## **URGENT – Medical Device Correction Field Safety Notice**

### **Philips V60/V680 Ventilator Serviced With Touchscreen RP Kit 453561511951 May Be Impacted by Unresponsive Touchscreen**

A problem has been detected in certain Philips V60 and V680 Ventilator touchscreens, which could pose a risk for patients or users. This FSN86600045 is intended to inform you about:

**Touchscreen Serial Number Location**

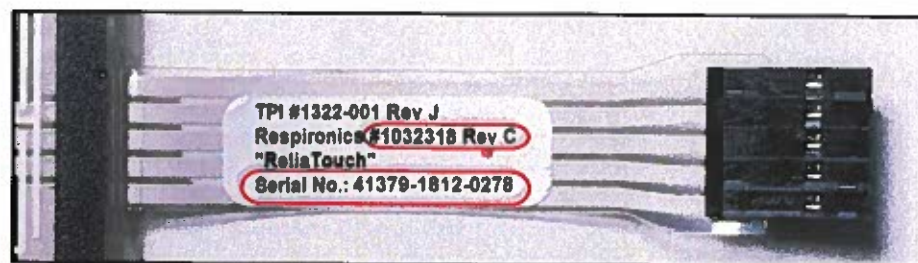
- 1) Check your unused Touchscreen RP kits ordered/received as PN 453561511951 by referring to the part number/serial number label located on the flex cable of the touchscreen inside the kit, and verify its serial number against the affected serial numbers listing of Table 1 in the "Affected Products" section.

<b>ACTIONS PLANNED BY PHILIPS</b>	<p>Upon receipt of acknowledgement by the customer with the affected serial number(s) of any unused touchscreen RP Kit 453561511951 at their site, Philips will provide to the customer P/N 453561539071 (1032318 Rev E) at no charge.</p> <p>Additionally, customers who ordered and installed Touchscreen RP Kit PN 453561511951, or were serviced by Philips or Third Part biomedical engineers using PN 453561511951, are requested to contact Philips if the V60 or V680 ventilator touchscreen fails. A Philips Engineer or an Approved Service Provider will evaluate the cause and if applicable, replace the touchscreen at no charge to the customer per the appropriate FCO document.</p>
<b>FURTHER INFORMATION AND SUPPORT</b>	<p>Monday through Friday between 8:00am and 5:00 pm US Pacific Time  <b>Firm responsible for FSN:</b>  Respironics California, LLC  2271 Cosmos Court  Carlsbad, CA 92011</p> <p><b>Primary Contact</b>  Melissa Abbott  Sr. Post Market Surveillance Manager  Phone: +1 (760) 918-7300  E-mail: <span style="background-color: black; color: black;">[REDACTED]</span></p> <p><b>Local Contact</b>  Enter local contact info here</p>
